NORTH SYDNEY COUNCIL REPORTS

#### NSLPP MEETING HELD ON 03/08/2022

ADDRESS/WARD:	145 Carabella Street, Kirribilli
APPLICATION No:	D46/22
PROPOSAL:	Alterations and additions to an existing two (2) storey dwelling including a second floor addition at the rear of the dwelling.

OWNER:	Leon Varley
APPLICANT:	Jan Lochtenberg
AUTHOR:	Robin Tse, Senior Assessment Officer
DATE OF REPORT:	26 July 2022
DATE LODGED:	11 February 2022
<b>RECOMMENDATION:</b>	Approval (Deferred Commencement)

Figures 14-16: Shadow diagrams (Mid-winter)

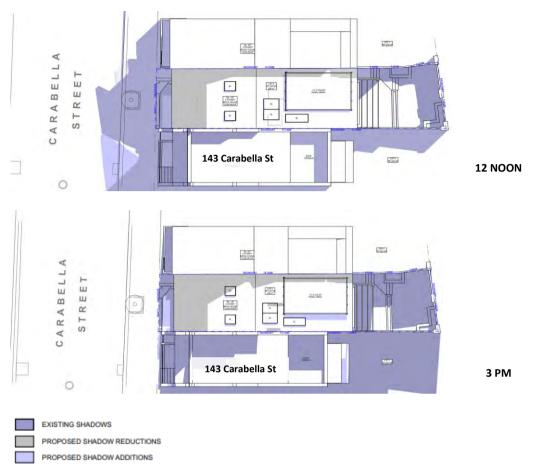
(1)(c) To maintain solar access to existing dwellings, public reserves and streets, and to promote solar access to future development – An examination of the submitted shadow diagrams has revealed that the new shadows caused by the non-complying building elements, would generally fall on the adjoining property to the south-east at No.143 Carabella Street and Carabella Street (Figures 14-16).

Figure 17: Design amendments (Deferred commencement)

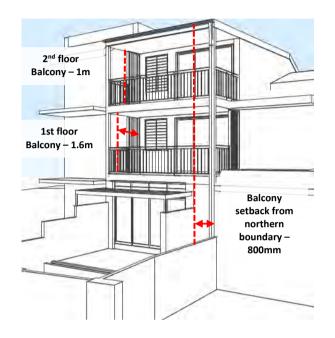
Furthermore, the depth of the proposed first floor balcony (at 2.2m) can be reduced to match that of the existing first floor balcony (at 1.65m) to minimise any further visual and/or acoustic privacy impacts for the adjoining properties.

In addition, the northern edge of the proposed first and second floor balconies do not provide setback from the common property boundary with No.147 Carabella Street. It is considered that the northern edge of the first and second floor balconies are to be setback from the common property boundary with No.147 Carabella Street by 800mm to match the width of the right-of-passageway on the ground floor (Figure 17).

In addition, the installation of full height privacy screen along the northern edges of the first and second floor balconies should enhance visual privacy protection for No.147 Carabella Street.

- AA1. The design of the first and second floor balconies on the rear elevation of the proposed dwelling must be modified as follows:
  - (a) The north-western edges of the proposed first and second floor balconies shall provide a setback from the norther-western common property boundary with No.147 Carabella Street by a minimum of 800mm;
  - (b) The depth of the first floor balcony shall be amended to 1600mm from the rear (north-eastern) building line of the main dwelling;
  - (c) The depth of the second floor balcony shall be amended to 1000mm from the rear (north-eastern) building line of the main dwelling;
  - (d) The depth of the awning over the second floor balcony shall match the depth of the second floor balcony (1000mm); and
